### HENDERSON COUNTY PLANNING BOARD

**SUBJECT:** Revised Master Plan and Development Plan for The Boulders Subdivision

(2007-M01) (2017 Revised Master and Development Plan)

### **Henderson County Planning Department Staff Report**

Map C: County Comprehensive Plan Future Land Use Map

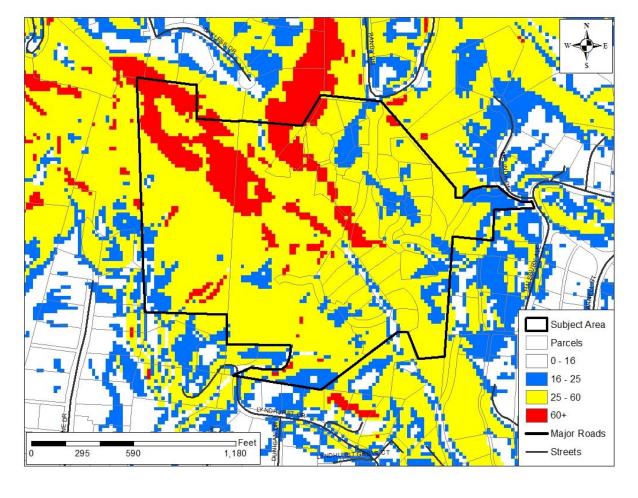
- (a) **Conservation Area.** The conservation area designation is applied to a majority of the project site, largely due to slope and a protected mountain ridge (See Map C: CCP Future Land Use Map, Map D: Slopes Map, and Map E: Protected Ridges). The overwhelming majority of slopes within the project site appear to be in excess of 25 percent, with portions having slopes in excess of 60 percent. According to the plan, only a minority of the steep slope areas within the project site appear to be located in designated common area/open space. The CCP states that conservation lands "are intended to remain largely in their natural state, with only limited development," and further that "such areas should be targeted for protection through regulations and incentives" (2020 CCP, Pg. 138).

(b) **Urban Services Area.** The Urban Services Area (USA) designation of the Growth Management Strategy is applied to portions of the project site. The USA is that area within which most urban services and urban-scale development is currently concentrated, and within which such development should generally be concentrated through the year 2020 (CCP, Pg. 132). The text and map of the 2020 CCP suggest that wide ranges of residential densities will exist in the USA. Over the long term, land use regulations and policies should favor higher density development, consistent with natural constraints and the availability of urban services. At the same time, policies and regulations should protect existing less-intensely developed communities. (CCP, Pg. 133)

According to the plan, the project would have an average density of approximately 1.03 units per acre. The CCP states that higher density residential development should be concentrated in the Urban Services Area and that regulations should target Conservation Area and areas with steep slopes for protection.

**Map E: Protected Mountain Ridges Map**

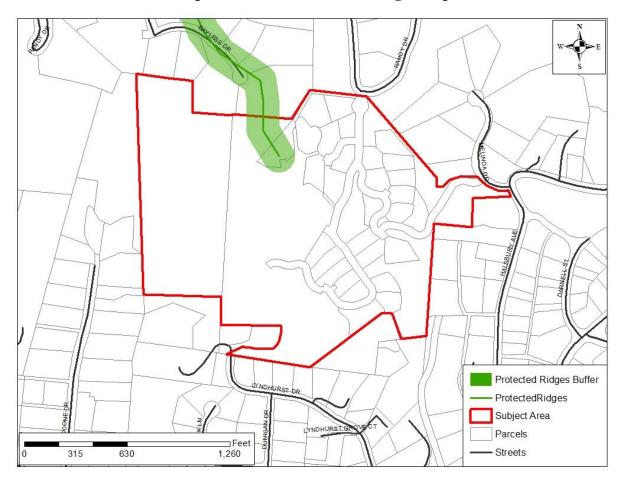
1. **Protected Mountain Ridges**. The project site appears to contain an area effected by the Mountain Ridge Protection Ordinance which states that the provisions of NCGS 113A-209 apply to all mountain ridges in Henderson County whose elevation is 500 feet or more above the adjacent valley floor (Map E: Protected Mountain Ridges). NCGS 113A-209 states that no county may authorize the construction of, and no person may construct, a tall building or structure on any protected mountain ridge. The definition of a tall building found in NCGS 113A-206 is any building with a vertical height of more than 40 feet measured from the top of the foundation and the uppermost point of the building. Additionally, where such foundation measured from the natural finished grade of the crest or the natural finished grade of the high side slope of a ridge exceeds three (3) feet, then such measurement in excess of three (3) feet shall be included in the 40-foot limitation provided that no such building protrudes at its uppermost point above the crest of the ridge by more than 35 feet. The area of ridge under protection is defined as the elongated crest or series of crests at the apex or uppermost point of intersection between two (2) opposite slopes or sides of a mountain, and includes all land 100 feet below the elevation of any portion of such line or surface along the crest. Planning Staff recommends, as a condition of approval, that the Applicant shall adhere to the Mountain Ridge Protection regulations of the County which state that the provisions of NCGS 113A-209 apply to all mountain ridges whose elevation is 500 feet or more above the

adjacent valley floor. Planning staff also recommends that the applicant be required to delineate the protected ridge area on the development plan(s) showing the area within 100 feet below the crest(s).

**Map F: Official Zoning Map**

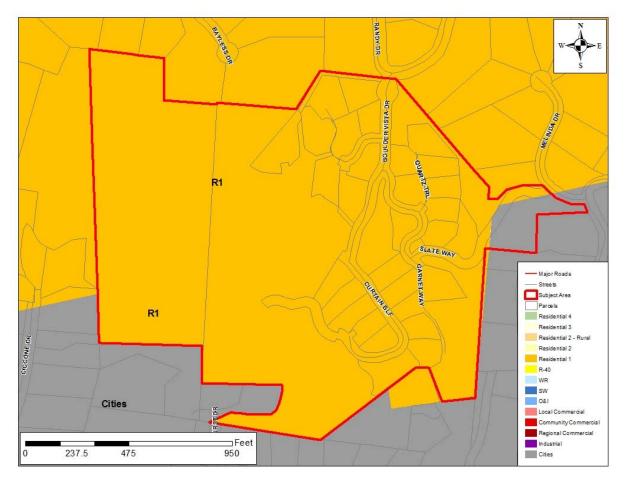
2. Chapter 200A, Henderson County Land Development Code (LDC). According to Chapter 200A, Henderson County Land Development Code (LDC) and its Official Zoning Map adopted September 19, 2007 (as amended), the proposed project site is located within the Residential One (R1) (See Map F:Official Zoning Map). The R1 district allows for single-family residential development.

R1 allows for a standard residential density of 4 units per acre where the slope is less than 60 percent. At total of 34.9 acres are in this category, meaning 139 units would be permitted within this acreage. Where slopes are 60 percent or greater, the density shall be one-half(½) of the eligible density (2 units per acre). A total of 6.8 acres of the project site are in this category, meaning a total of 13 units would be permitted. Therefore, the LDC allows for a maximum of 153 units on the project site. The Master Plan proposal of 58 units would fall within the density permitted by the LDC.

Map G: Public Water and Sewer Map

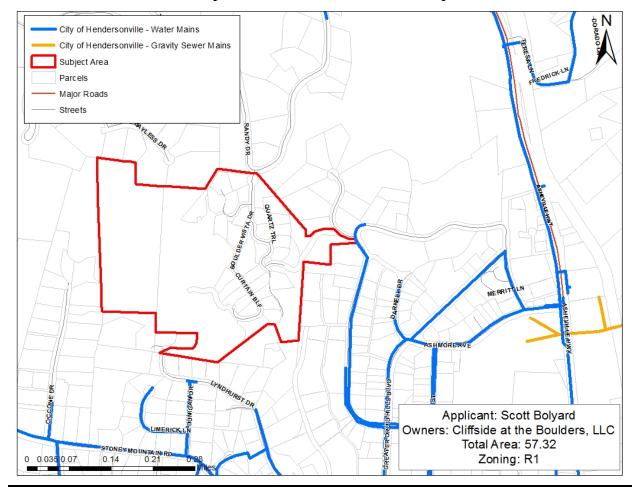
3. Water and Sewer Availability. Applicant proposes a public connection to the City of Hendersonville water system on Melinda Drive. The water system within the project site is proposed to be private. The distance to public water from the project site on Melinda drive is 100 feet. The distance to public water from the project site on Lyndhurst Drive is 400 feet.

Applicant proposes private septic systems. Master plan provides a distance to public sewer (from Randy Drive to US 25 N) of 3,500 feet. The site is not close enough to public sewer to require connection (LDC §42-113 C.5).
